Bryant Development and Review Committee Meeting

Date: April 27, 2023 - **Time:** 9:11 AM

Comment Responses for Midland Road Estates Subdivision

Comment Responses for Hilltop Landing

C.A.D. BY: DRAWING NUMBER: 4/19/2023 REVISED: CHECKED BY: SHEET: C-5.0 15W 0 34 230 62

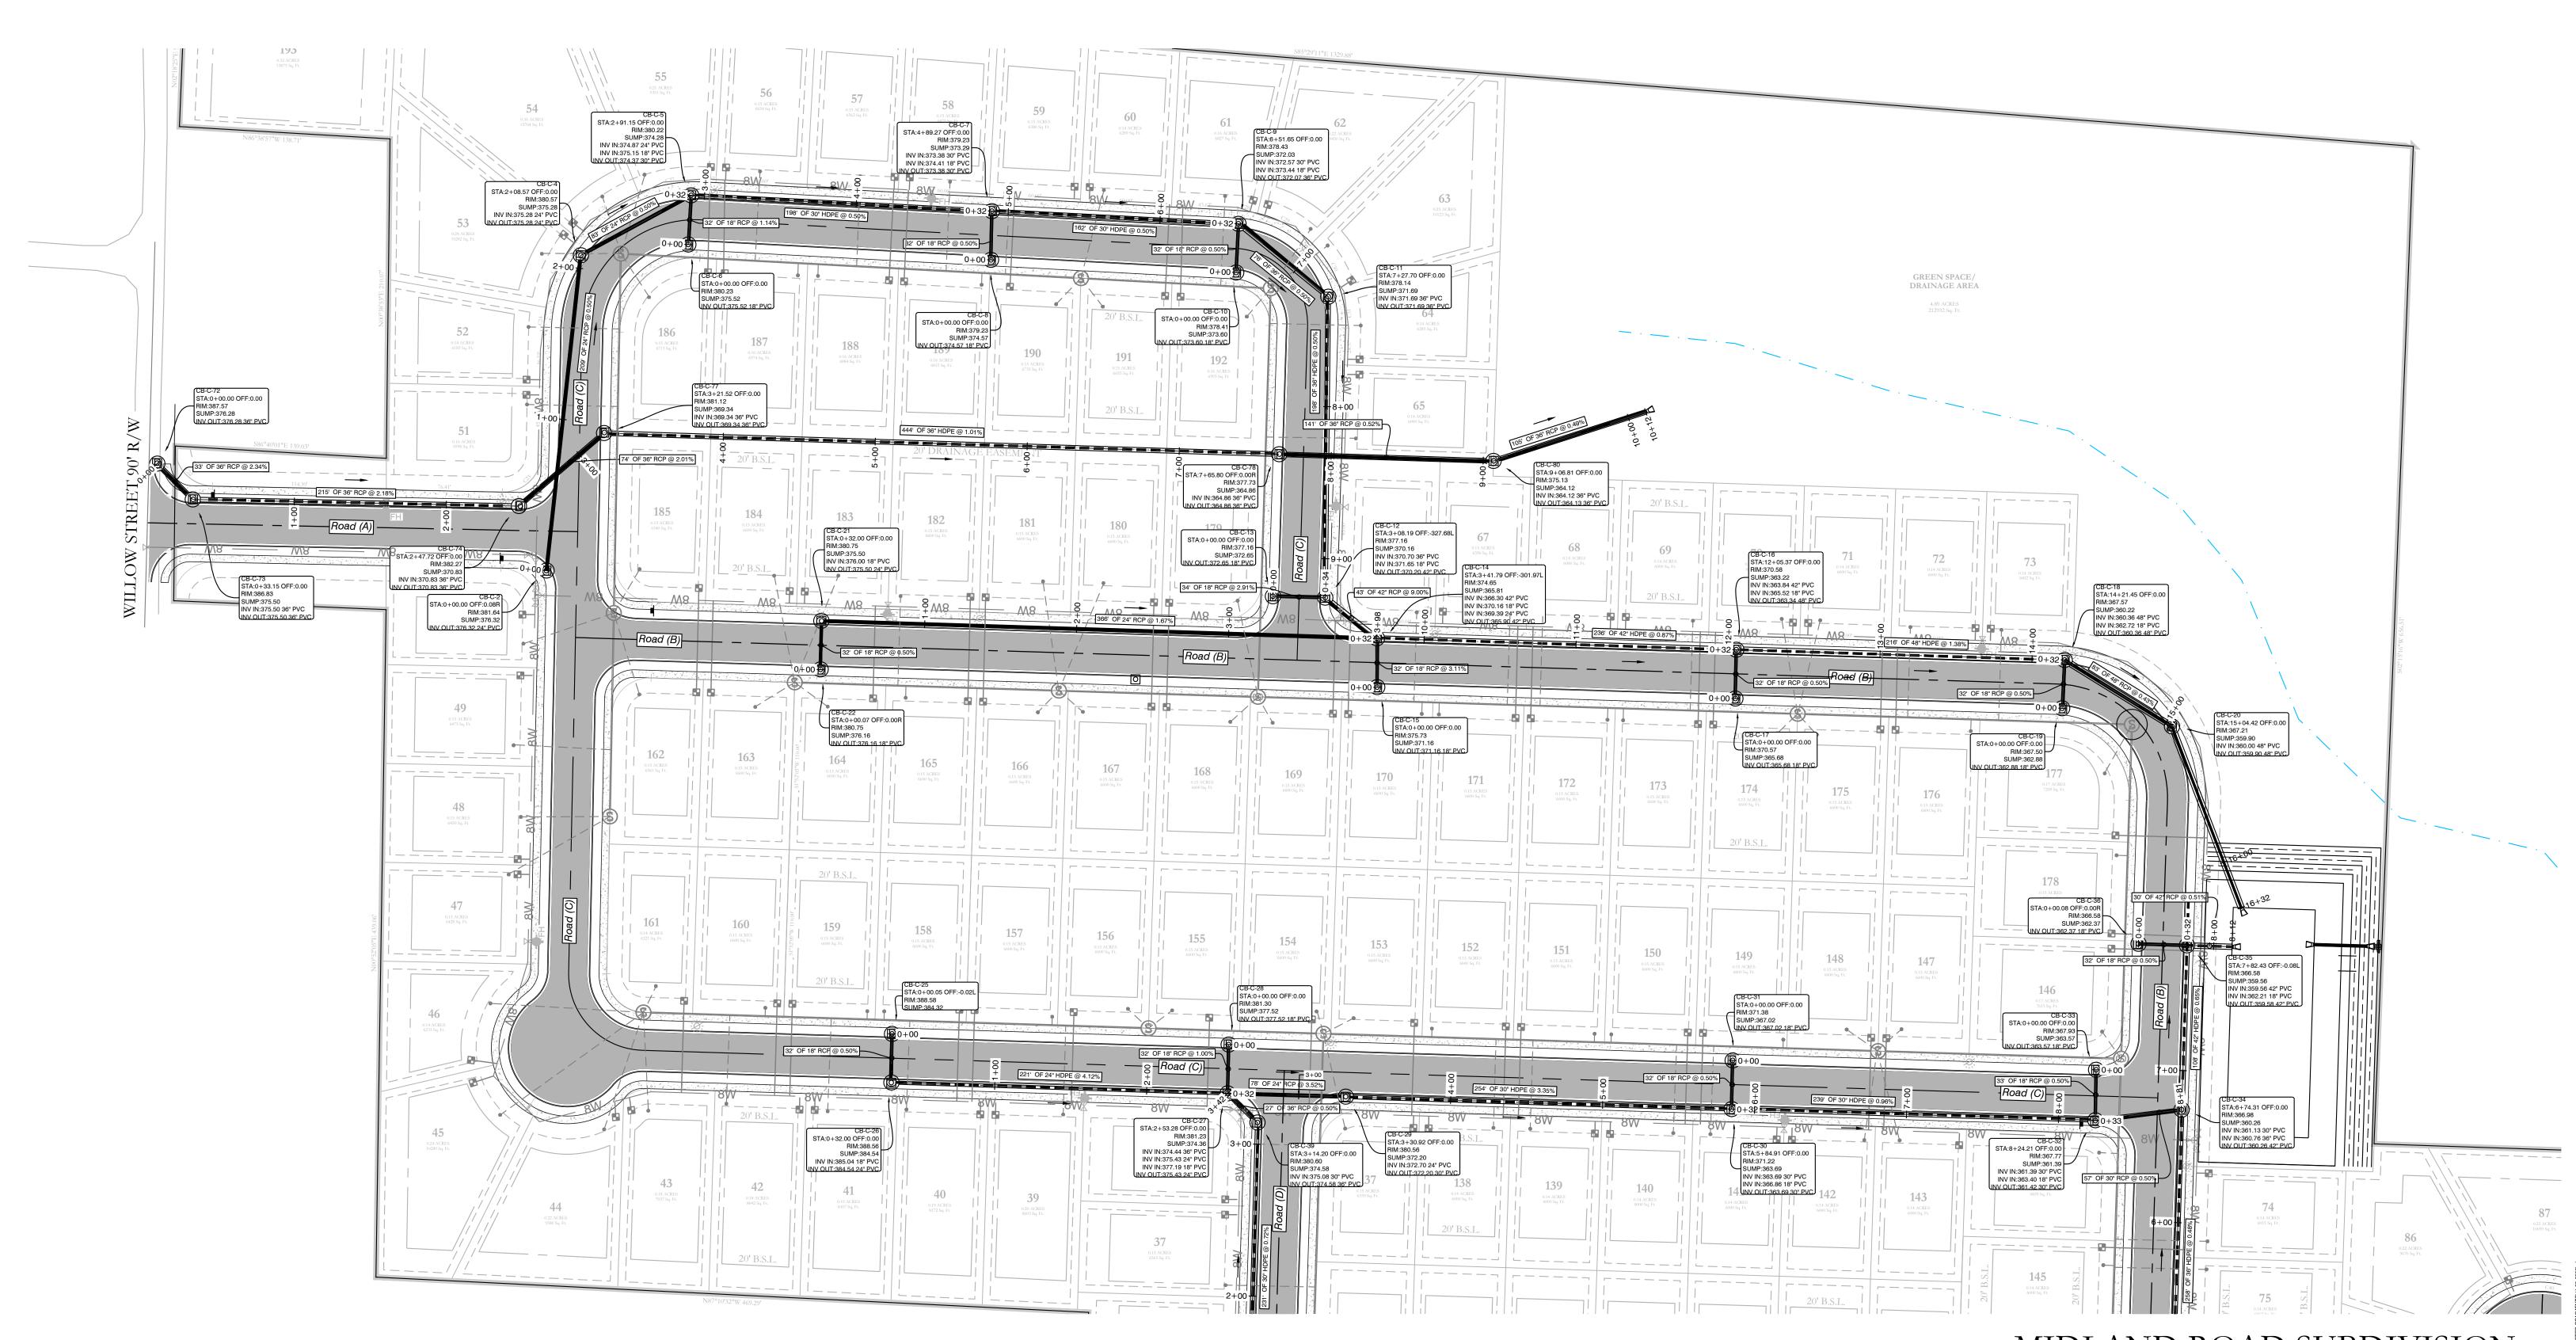
Comment no.6- Sheet C-5.0 shows sidewalk width "4ft or 5ft" in width. City specs are 5ft.

Response- Sheet C-5.0 has been corrected.

BRYANT, SALINE COUNTY, ARKANSAS DRAWING NUMBER: C.A.D. BY: 4/19/2023 REVISED: CHECKED BY: 23-0024 C-6.16 SCALE: SHEET:

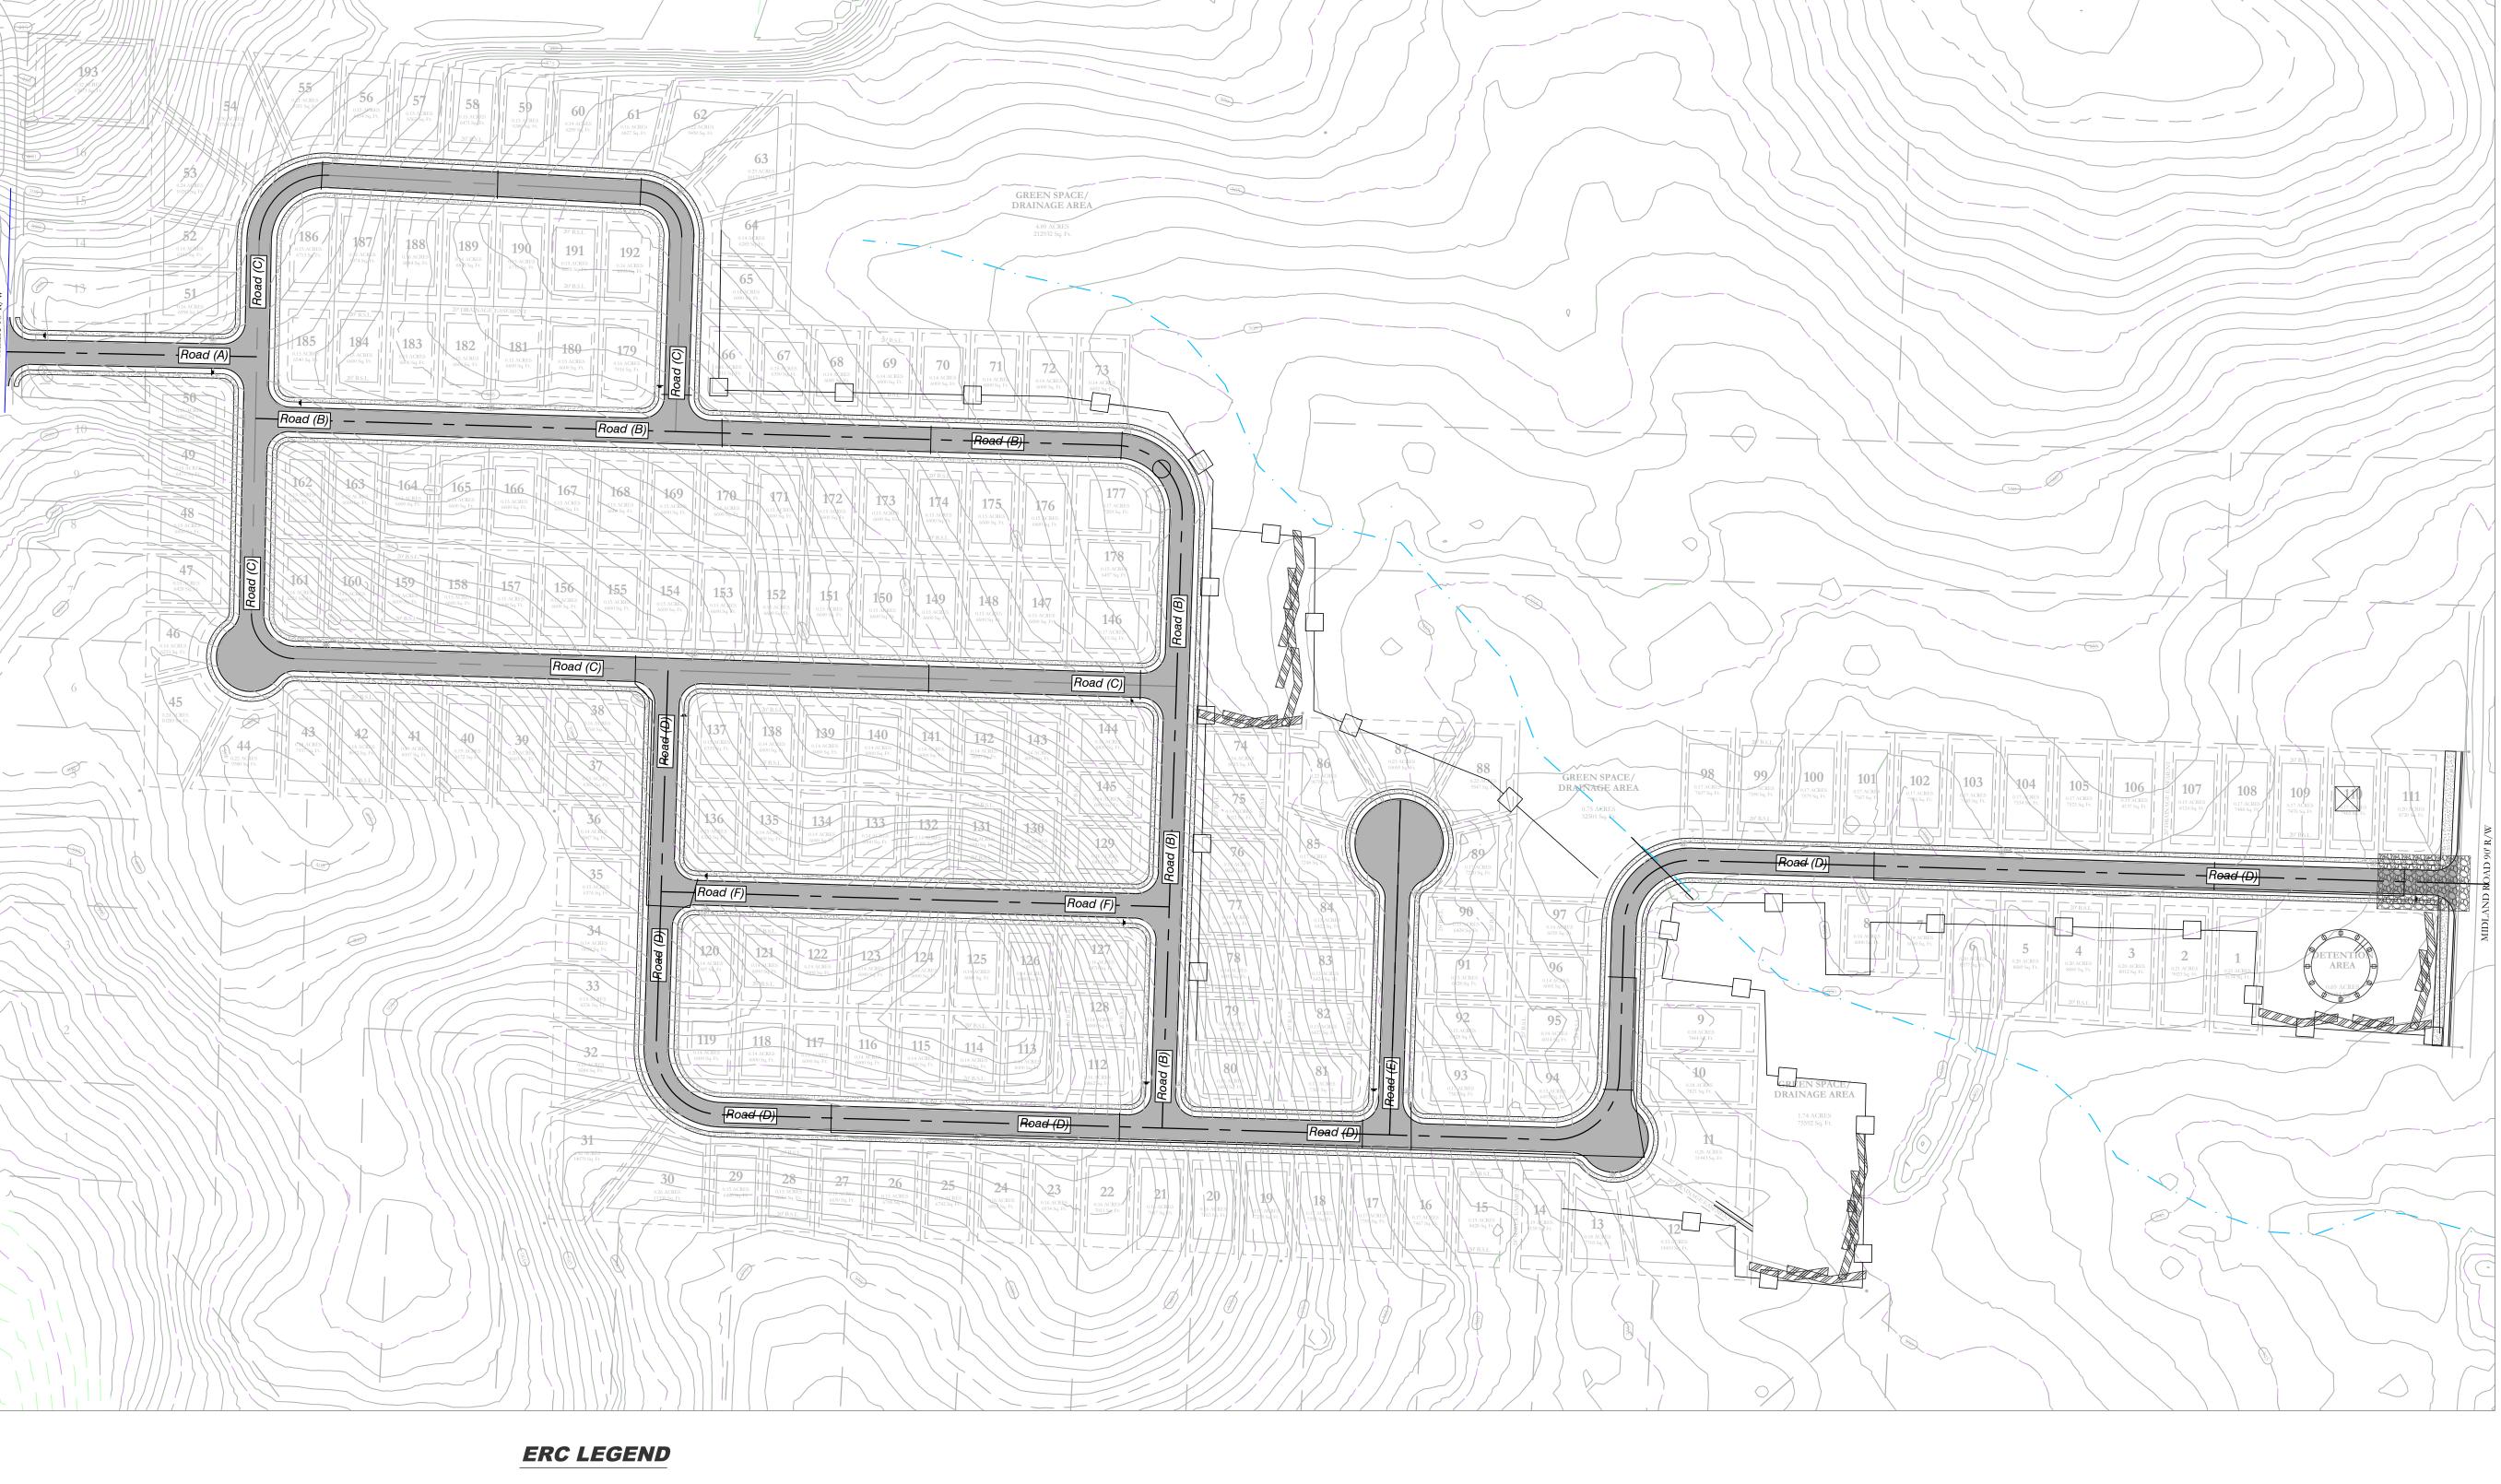
Comment no.4- Discuss placement of spillway' on detention/retention ponds.

Response- Spillway locations have been provided. See (C-6.16).
